Agnico Eagle Meliadine Waste Rock Storage Facility 1 Design Report and Drawings

You will find below Agnico Eagle's answers to the NWB/CIRNAC/KvIA questions on the WRSF1 design report and drawings. We remain available should any additional questions/clarification be needed.

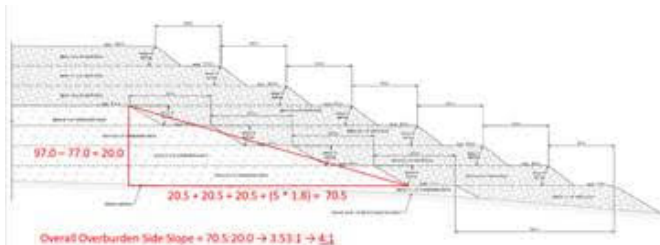
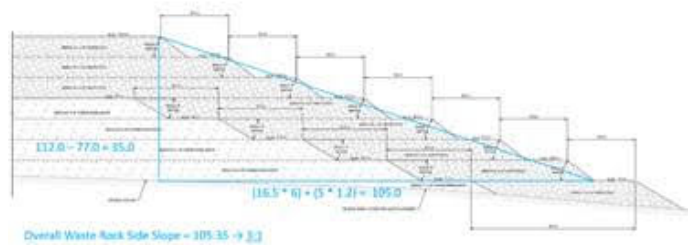
2. *Table 4 shows that the slopes for overburden and waste rock will be at 4:1 and 3:1, respectively. However, Section 5.2 provides different side slopes of 1.8:1 for overburden and 1.2:1 for the waste rock. Are these the dimensions before the modifications implemented to maximize the storage?*

As shown in the design drawings, WRSF1 will be built in a series of "benches", with each bench generally representing one "lift" of material of maximum 5.0 m height. Table 4 provides the overall multiple-bench side slopes for the overburden and waste rock within the WRSF (crest of top bench to toe of bottom bench) as shown below. Section 5.2 however, provides the assumed side slopes for the different material types for each individual "bench" or "lift" and are indicated on the design drawings as "angle of repose". The angle of repose values quoted in Section 5.2 reflect the angle of repose or friction angle values used in the stability analysis.
